Project	IEEE 802.16 Broadband Wireless Access Working Group <http://ieee802.org/16>	
Title	Integration of comments #5482, #5484, #5487, their reply comments, contribution 289, 305 and 118r4 on fast DL S/N measurements	
Date Submitted	2005-06-16	
Source(s)	Masoud Olfat Nextel Communications 12000 Sunrise valley Dr. Reston VA 20191	Masoud Olfat Nextel Communications 12000 Sunrise valley Dr. Reston VA 20191
Re:	IEEE P802.16e/D8	
Abstract	This contribution integrates comments #5482, #5484, #5487, their reply comments, contribution 289, 305 and 118r4 on fast DL S/N measurements, and changes some portions based on the D8 draft.	
Purpose	Discuss and approve.	
Notice	This document has been prepared to assist IEEE 802.16. It is offered as a basis for discussion and is not binding on the contributing individual(s) or organization(s). The material in this document is subject to change in form and content after further study. The contributor(s) reserve(s) the right to add, amend or withdraw material contained herein.

Integration of Comments 5482, 5484, 5487 and all their reply comments, contributions 289, 118r4, 305

Masoud Olfat
Nextel Communications

Figure 230a – Post Processing S/N for MIMO Region

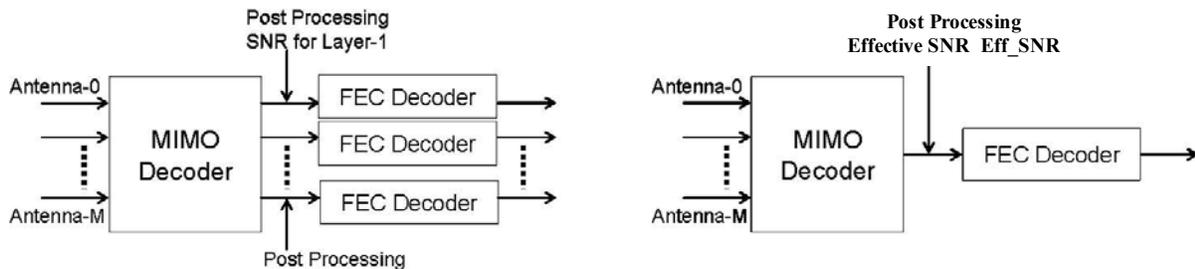
[\[Replace the first half of the figure 230a with the one from contribution 305\]](#)
